**R44**

**SERVICE BULLETIN SB-39**

**SUBJECT:** Horizontal to Vertical Stabilizer Attach Channels

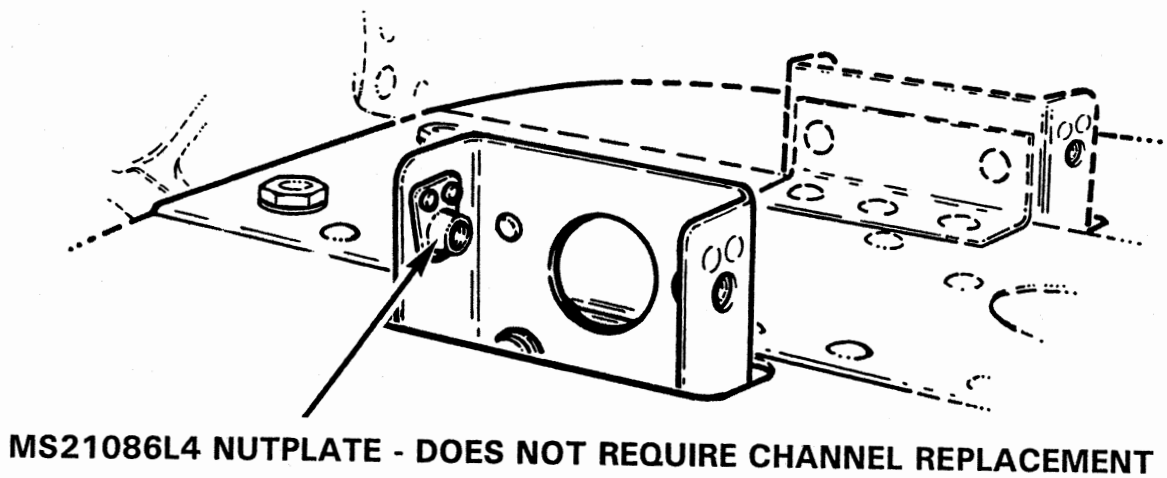
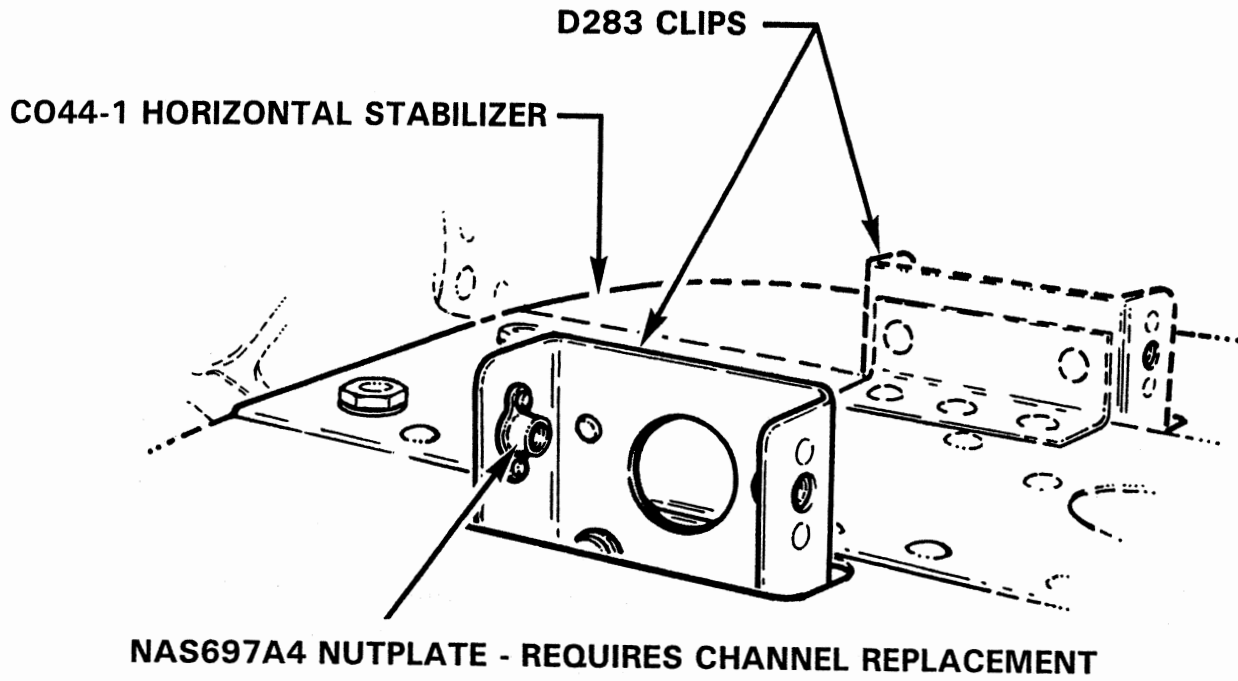
2. For affected stabilizers, remove upper vertical stabilizer per R44 MM Section 4.323(a). Inspect attach bolt nutplates on D283 channels (see figure on page 2). If nutplates are MS21086L4, channel replacement is not required. Reinstall stabilizer per R44 MM Section 4.323(e).

3. If nutplates are NAS697A4, remove empennage per R44 MM Section 4.321 and return all three stabilizers to RHC for D283 channel replacement. Channels may only be replaced at RHC, and all three stabilizers are required to ensure proper nutplate location on new channels.
